F0138-HOYA-US(PCT)

Attorney Docket: 3836.001 April 16, 2010 (1:12PM)

Remarks

The Present Invention

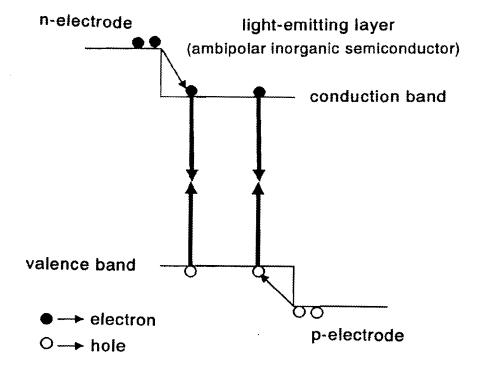
In claim 18, the examiner states that the conduction band energy is not defined since no reference energy level is defined. The examiner does not completely read the claim which

The present invention is based on ambipolar diffusion and recombination while Kawazu is based on quantum well. The following page includes presentation material provided by the assignee to illustrate the difference of the two. The circles represent holes.

Note in the above figure the lack of a barrier between the n-electrode and its associated work function and the conduction band and between the p-electrode and its associated work function and the valence band.

compares the conduction band edge energy to the work functions of the n-electrode and of the p-electrode. Only the differences between the band edge energies and the two work functions are important. All three are individually measured from a common reference energy, typically the Fermi energy although other reference energies may be used. In the differences, the reference energy cancels out and thus is unimportant and the differences are non-ambiguous despite the undefined reference energy. Typically, work functions are defined with respect to the vacuum level removed from the atom having an energy of 0 eV. Applicants are willing to amend claim 18 to define the conventional reference level, as is well known in the art. However, since only differences of energy levels are recited, the reference level can be any value without affecting the meaning of the claim.

- The light-emitting layer is an ambipolar inorganic semiconductor including no dopant.
- Drift conduction in the light-emitting layer is obtained by carriers injected from the outside.
- Since the mobility of both carriers is in the same range (1/10~1), recombination emitting is obtained at the midpoint of the light-emitting layer.
- More than a band gap energy of the light-emitting layer is necessary for drive voltage.
- The thickness of the light-emitting layer is 10nm~10µm.

Fig. 1 of Japanese Patent Application Publication No. 4-120775

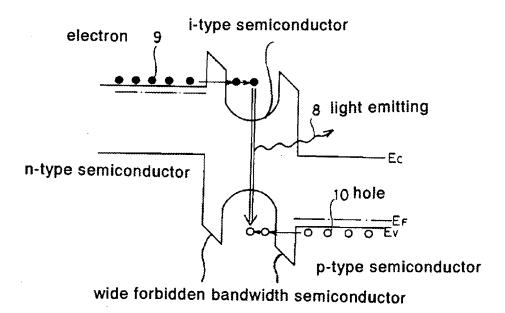
The following page is presentation material for the conventional quantum well structure to be contrast with the invention.

- Both carriers are injected to a light-emitting layer by tunneling the potential barrier.
- · Both carriers are shut in the potential barrier.
 - → Recombination emitting occurs because
 the distance between both carriers becomes close.
 (Since the carriers are shut in, there is no movement
 (In the direction of electric field) in the light-emitting layer)
- The drive voltage is more than shut-in level.
- The thickness of the light-emitting layer is thin in general, and no more than about 10nm.

A quantum well structure is characterized by an light-emitting active area comprising two wide-bandgap semiconductor (insulator) layers acting as tunneling barriers or potential barriers of the quantum well and a narrow-bandgap semiconductor layer betweeem the barrier layers acting as a shut-in area (well) of the quantum well. In the light-emitting active area, at least one additional shut-in or confinement quantum level of electrons or holes is formed within the well and away from the respective valence and conduction bands of the well. Light emission occurs by the transition between the two additional confinement levels associated with conduction and valence bands respectively. Therefore, electrons and holes do not transport in the light-emitting active area (i.e. shut-in state) between the electrodes. Thus, the quantum well structure has the "quantum shut-in" or confinement structure which is unrelated to the ambipolar semiconductor based on the drift "conduction".

Accordingly, Kawazu's quantum well structure does not have the claimed ambipolarity. On the contrary, Kawazu's electrons and holes tunnel through his barrier layers.

The base claims 1, 13, and 18 have all been amended to require that the ambipolar light-emitting layer has a thickness of at least 100nm, as supported at [0015] of US 2006/0261350. In contrast, Kawazu's active layer, his quantum well, has a thickness of 10nm. No suggestion exists that Kawazu's active layer can be increased in thickness to 100nm and still function as his desired quantum well. On the contrary, it is well known in the field that quantum wells need to be have a thickness of less than about 10nm if they are demonstrate the confinement levels within the quantum well.
